## **ZONING CHANGE REVIEW SHEET**

CASE: C814-2018-0121 -- 218 South Lamar

TO: PUD

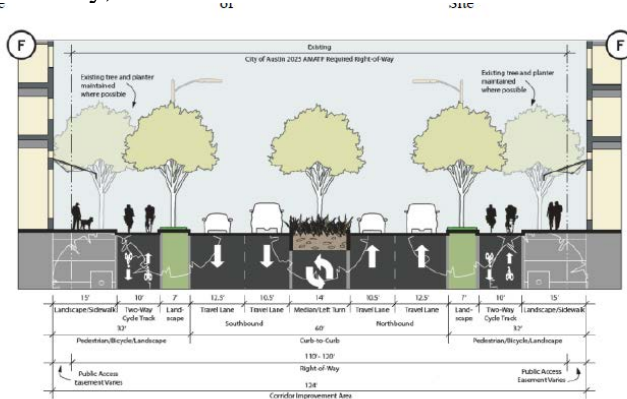
TR2. Include the below streetscape in the land use plan. Contact this reviewer for a more legible copy of it if necessary. This project is adjacent to a street that has been identified in Austin's Corridor Mobility Program (S Lamar). The sidewalk and bicycle facilities shall comply with the required cross-section at the time of the site plan application. The cross section that will be required is shown below. Find additional information about the Corridor Mobility Program here: <https://data.austintexas.gov/stories/s/Corridor-Mobility-Program/gukj-e8fh/>. Any proposed curb relocations on S Lamar requires coordination with the Corridor Planning Office and Bicycle Program. The cross section will include a 7' planting zone with street trees, a 10' two-way cycle track, and a 15' clear zone all behind curb. Additionally, a protected intersection will be required at Toomey, to be reviewed at the time of Site Plan.

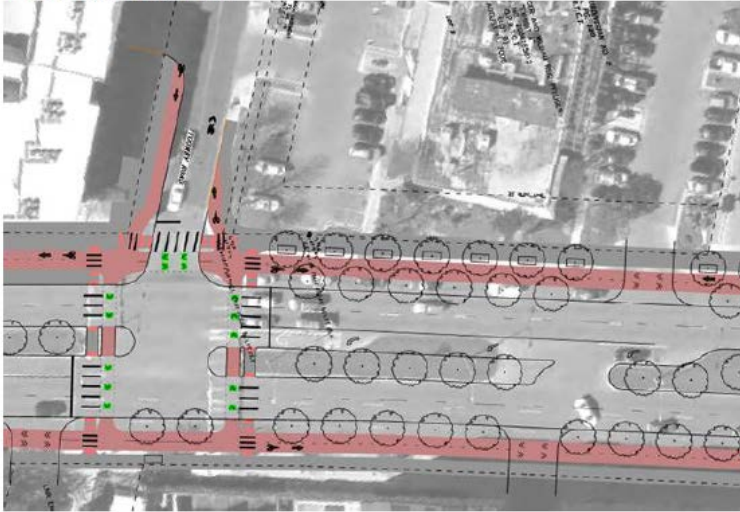
TR5. Bicycle facilities will be required along Toomey Road at the site plan stage. The design is below. Include the below graphic on the land use plan. If a more readable copy is required, contact this reviewer.
